DART AEROSPACE LTD		Work Order:	<i>102006</i>
Description: Crosstube Assembly (412 Low Narrow Aft)		Part Number:	D412-664-245
Inspection Dwg: D412-664-245 Rev: D		Page 1 of 2

DRAWING NO. D412-664-245	TITLE CROSSTUBE ASS'Y (412 LOW-N AFT)	REV. D	DART AEROSPACE LTD ENGINEERING ORDER		D.E.O. NO. D412-664-245-D-1	SHEET NO. SHEET 1 OF 2	SCALE NTS
DRAWN QP	CHECKED SC	MFG. APPR. R	APPROVED MP		DE APPR. H		
DATE 11.05.25	DATE 11.05.31	DATE 11.05.31	DATE 11/05/31		DATE 11.05.31

DRAWING NO. D412-664-245	TITLE CROSSTUBE ASS'Y (412 LOW-N AFT)	REV. D	DART AEROSPACE LTD ENGINEERING ORDER		D.E.O. NO. D412-664-245-D-2	SHEET NO. SHEET 1 OF 1	SCALE NTS
DRAWN 92	CHECKED ASS	MFG. APPR. E	APPROVED MP		DE APPR. H		
DATE 11.09.07	DATE 11.09.12	DATE 11.09.12	DATE 11.09.12		DATE 11.09.12

DRAWING NO. D412-664-245	TITLE CROSSTUBE ASS'Y (412 LOW-N AFT)	REV. D	DART AEROSPACE LTD ENGINEERING ORDER		D.E.O. NO. D412-664-245-D-3	SHEET NO. SHEET 1 OF 3	SCALE NTS
DRAWN 97	CHECKED J	MFG. APPR. DS	APPROVED AP	DE APPR. JH			
DATE 12.08.21	DATE 12.08.30	DATE 12.08.30	DATE 12.08.30	DATE 12.08.30	DATE 12.08.30

D412-664-245
ASSEMBLY DETAIL

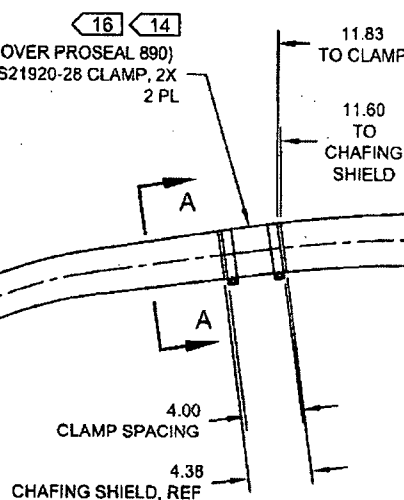
REMOVED ABRASION STRIP IN FAVOR OF A THIN LAYER OF PROSEAL 890. UPDATE INSTALLATION OF CHAFING SHIELDS AND REDUCE TORQUE TO 40-50 IN-LBS. THIS ENGINEERING ORDER SUPERCEDES DEO D412-664-245-D-1

IS:

D3189-1 CHAFING SHIELD (1, INSTALLED OVER PROSEAL 890)
MS21920-28 CLAMP, 2X
2 PL

D412-664-605
BENT TUBE

WAS:

D2856-600-1009 ABRASION STRIP
D3189-1 CHAFING SHIELD (1, INSTALLED OVER ABRASION STRIP)
MS21920-28 CLAMP, 2X
2 PL

D412-664-245
BENT TUBE
